Access Compliance Report

Public Rights-of-Way

(Curb Ramps)

Intersection ID: 14049	Main Street: CLEMENT_AV	Cross Street: PARK_DR	Location: SE
ADA ID: 346D8CB46AE6	Ramp Type: BlendTrans2	Initial Pass/Fail: Pass	Overall Compliance: No
		Severity Score: 0

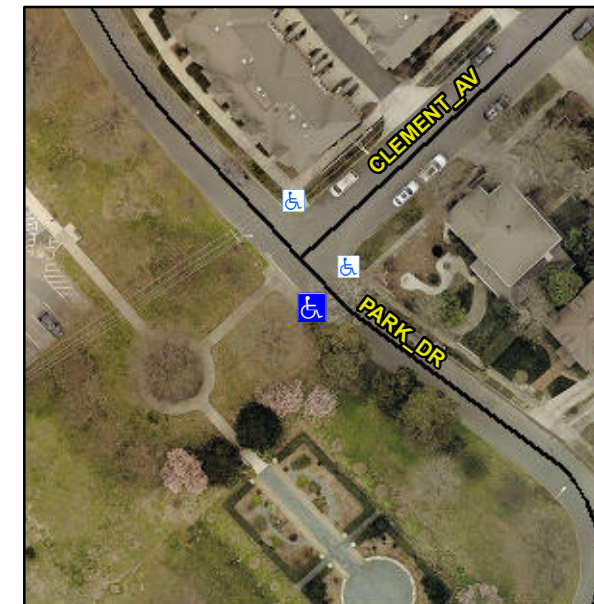
Not Found, R304.2.3

Remove & Replace Curb Ramp With Two New Directional Ramps or Equivalent.
